Watts Bar Nuclear Plant, Unit 2
NRC Docket No. 50-391

**Subject: Watts Bar Nuclear Plant Unit 2 – Submittal of Revised
Section 4.3.1, "Criticality" Developmental Revision G of the Unit 2
Technical Specification**

TS 4.3.1 Changes (Mark-Up) for WBN, Unit 2

FIGURE 4.3-3

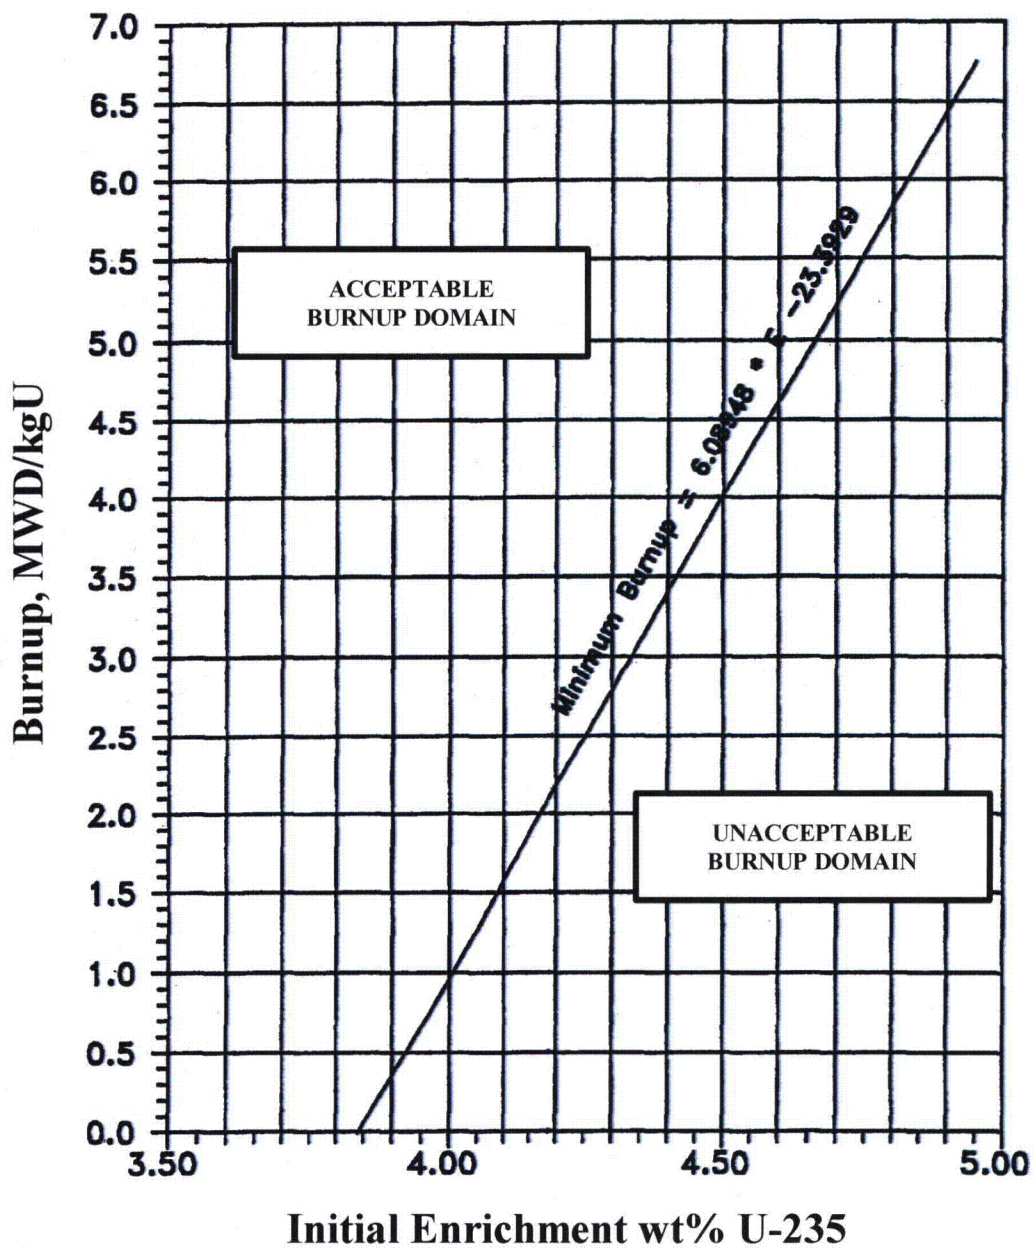
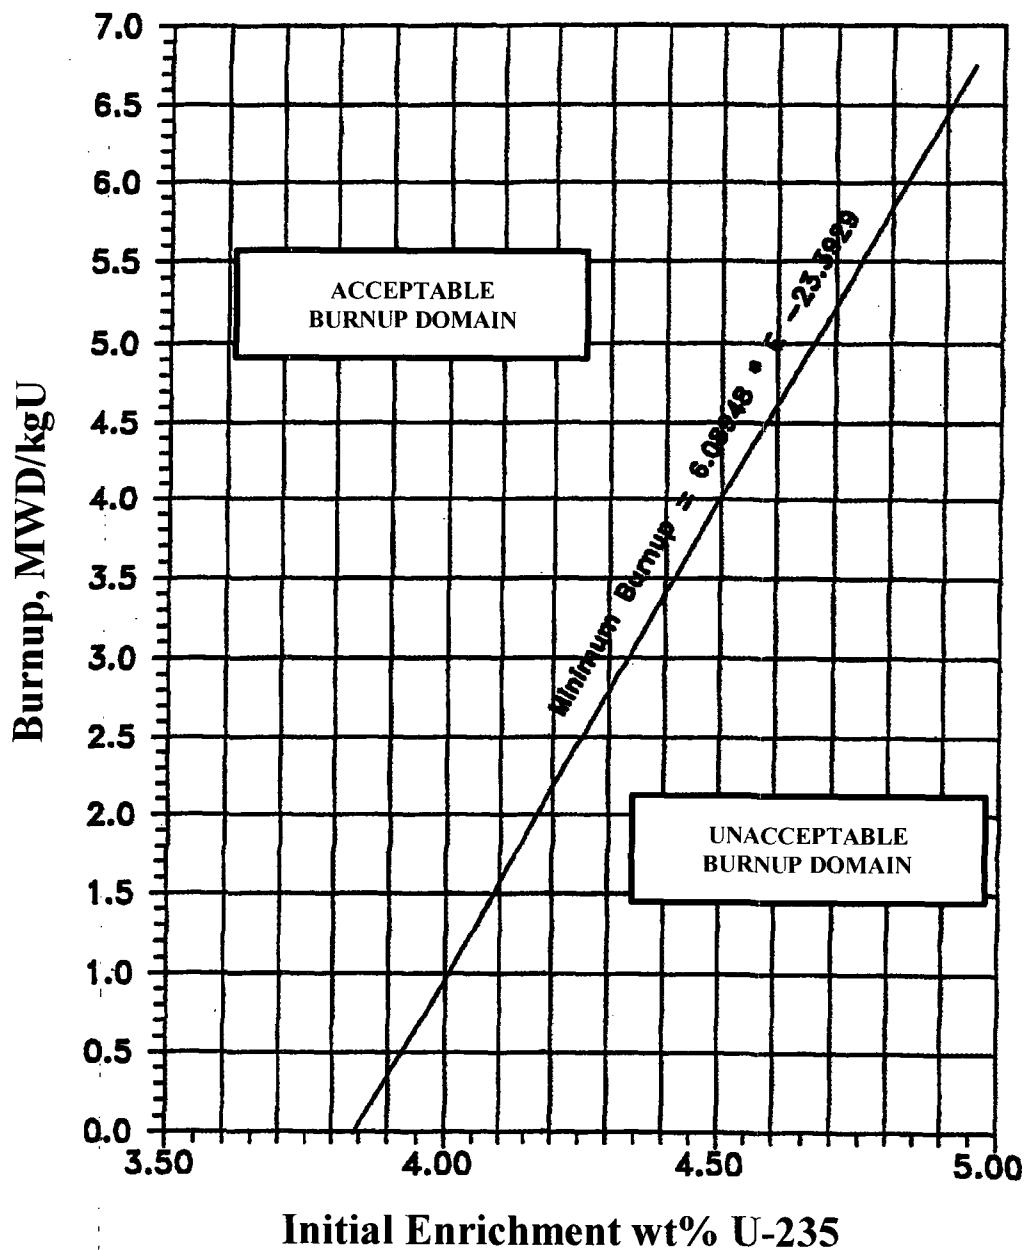
- ~~New and spent f~~ Fuel assemblies may be stored in the racks in an all cell arrangement provided the burnup of each assembly is in the acceptable domain identified in Figure 4.3-3, depending upon the specified initial enrichment.

MINIMUM REQUIRED BURNUP FOR UNRESTRICTED STORAGE
OF ~~NEW AND SPENT~~ FUEL OF VARIOUS INITIAL ENRICHMENTS

1. Fuel assemblies may be stored in the racks in an all cell arrangement provided the burnup of each assembly is in the acceptable domain identified in Figure 4.3-3, depending upon the specified initial enrichment.

MINIMUM REQUIRED BURNUP FOR UNRESTRICTED STORAGE
OF FUEL OF VARIOUS INITIAL ENRICHMENTS

FIGURE 4.3-46 MINIMUM REQUIRED BURNUP FOR UNRESTRICTED STORAGE OF FUEL OF VARIOUS INITIAL ENRICHMENTS

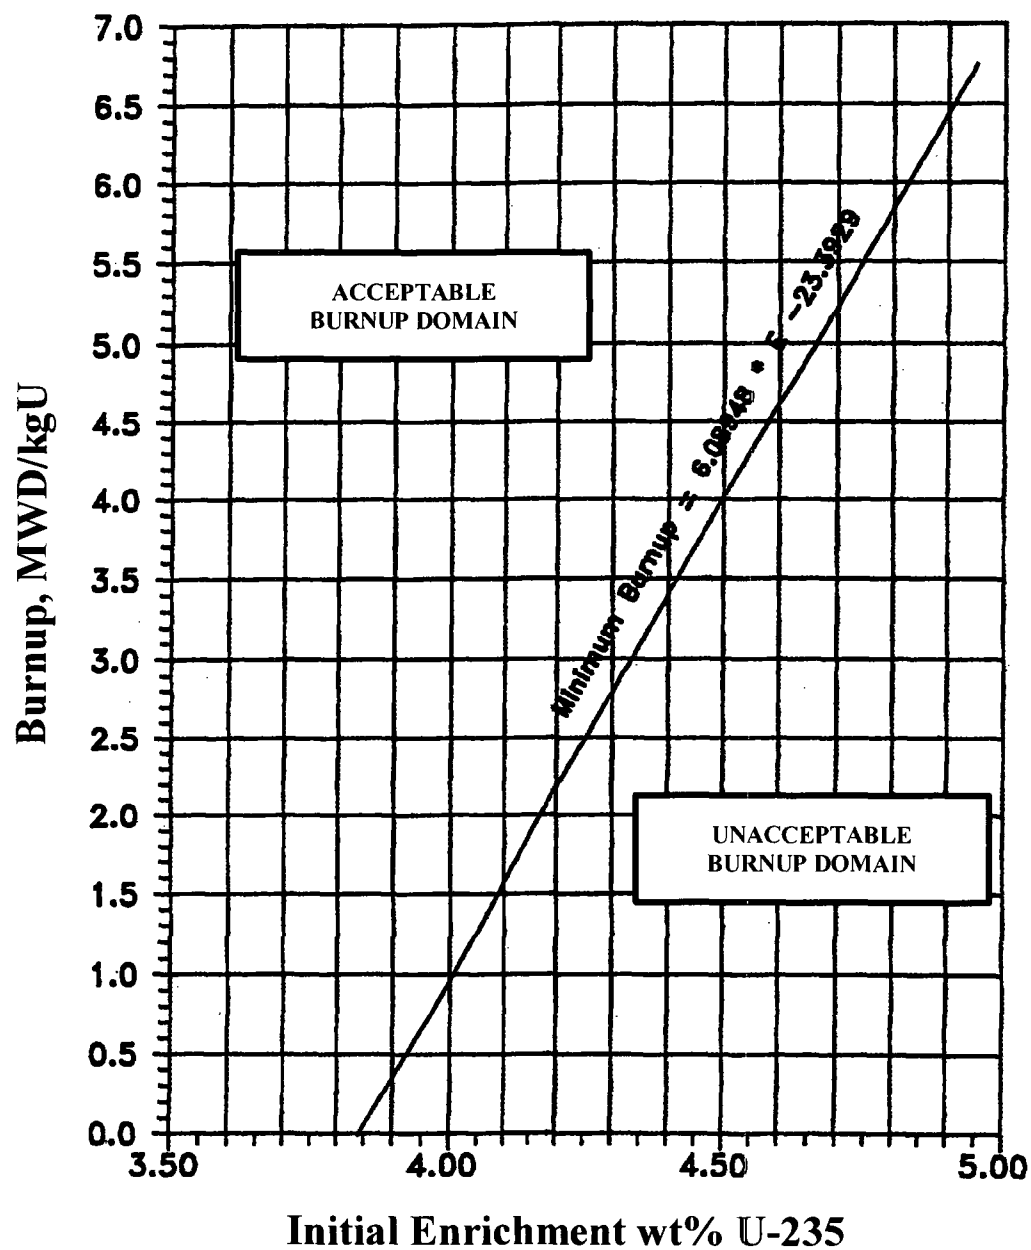
- (A) Fuel assemblies may be stored in the racks ~~without further restrictions in an all cell arrangement~~ provided the burnup of each assembly is in the acceptable domain identified in Figure 4.3-46, depending on the specified initial enrichment.
